Proposed Revisions to Seismic Design Standards of 2016 MOTEMS

Prevention First 2014

Rakesh K. Goel, PhD, PE, F.ASCE, F.SEI
Cal Poly, San Luis Obispo
rgoel@calpoly.edu

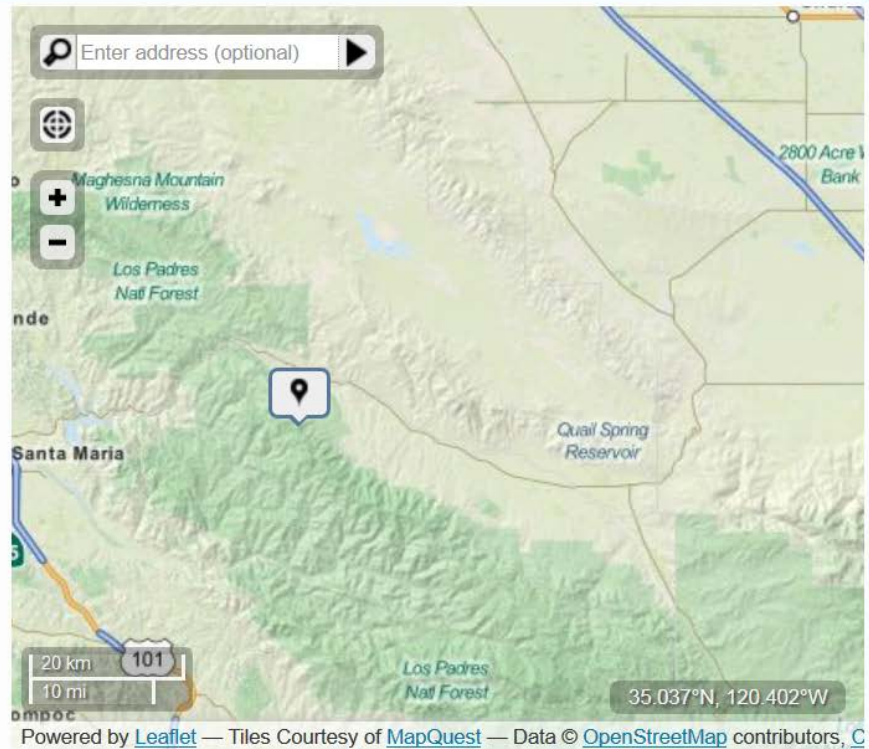
- Section 3103F.4.2.2 – Earthquake motions from USGS maps
 - <http://earthquake.usgs.gov/designmaps/us/application.php>
 - Select 2013 ASCE 41, Custom Earthquake Hazard Option, Required Probability of Exceedance, and Site Soil condition
 - Provides site corrected design spectrum
 - No need for manual adjustment for probability of exceedance
 - No need to site class adjustment
 - Delete section 3103F.4.2.4 which provides details of site class adjustment and construction of spectra

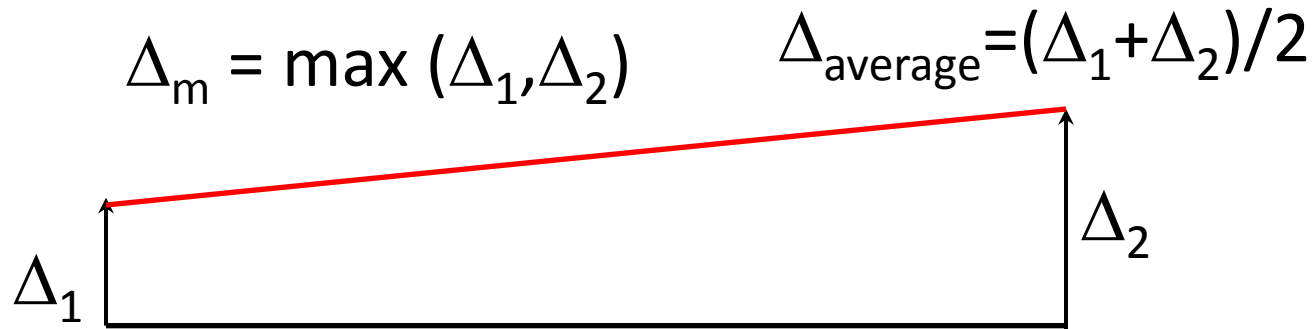
- ASCE 7-10 section 12.3.2.1 based irregularity classification
- Irregular if $\Delta_m > 1.2 \Delta_{\text{average}}$

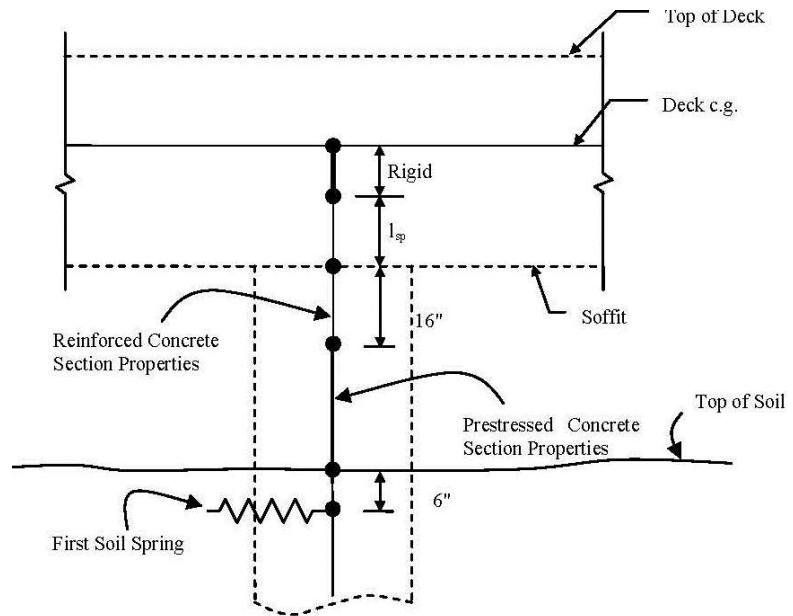
- Section 3104F.2.3.1.1 Modeling (add)
 - “The effects of connection flexibility shall be considered in pile-to-deck connection modeling. A procedure described in ASCE/COPRI 61-14 section C6.6.5 may be used for this purpose.”

FIGURE 31F-4-7
PLAN VIEW OF WHARF SEGMENT UNDER X AND Y SEISMIC EXCITATIONS [4.3]

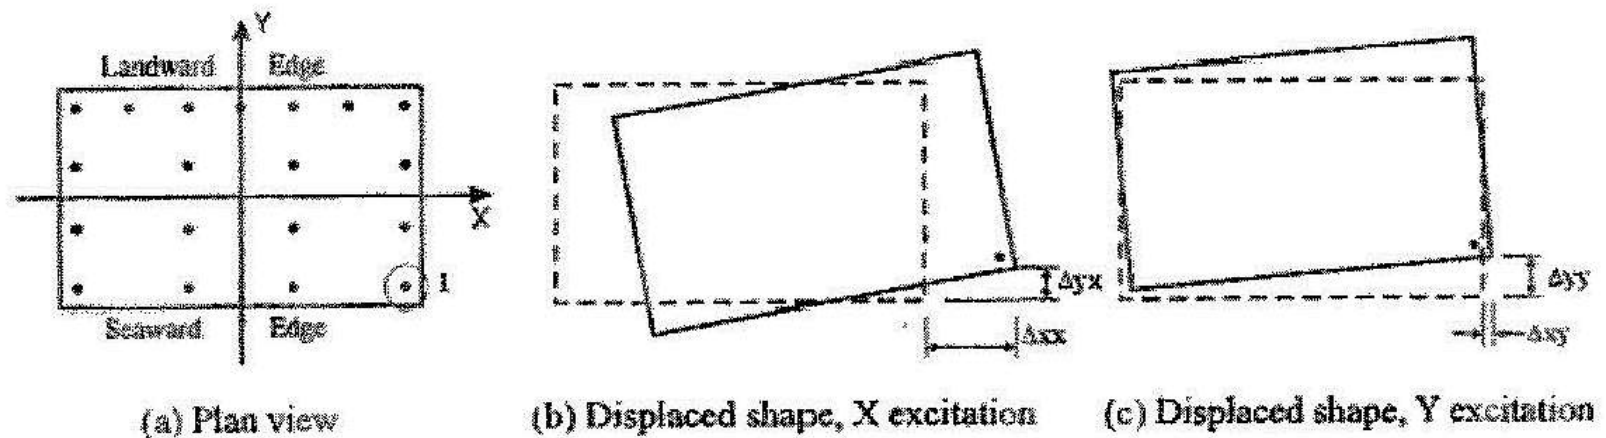
- Section 3104F.4.2 – Orthogonal effects
 - Revise symbols in Equations 4-7 to 4-11 to remove confusion

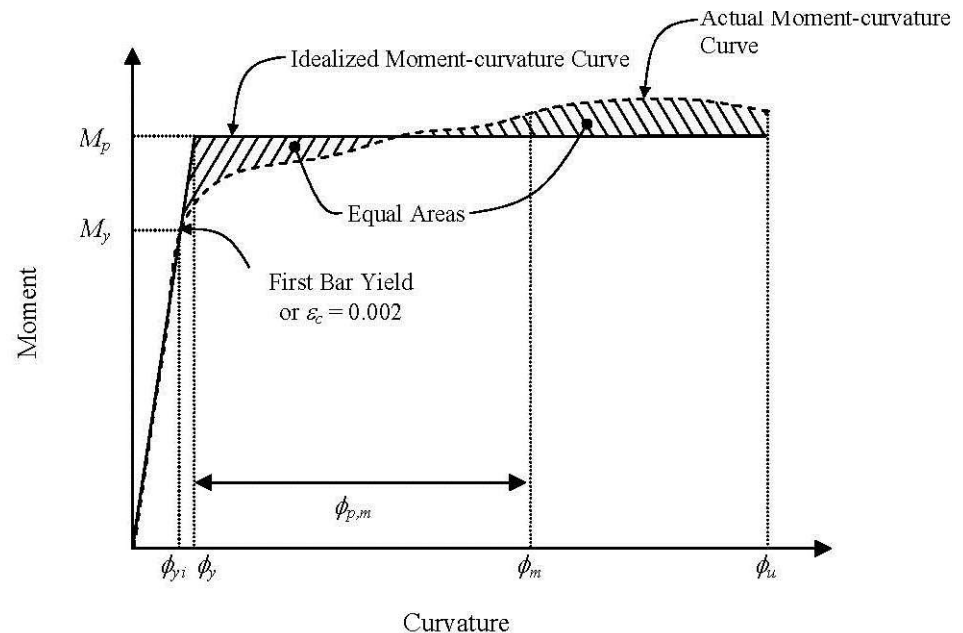
- Section 3107F.2.5.4 – Plastic rotation
 - Add ASCE/COPRI 61-14 Figure 6.5 as additional way to idealize moment-curvature relationship
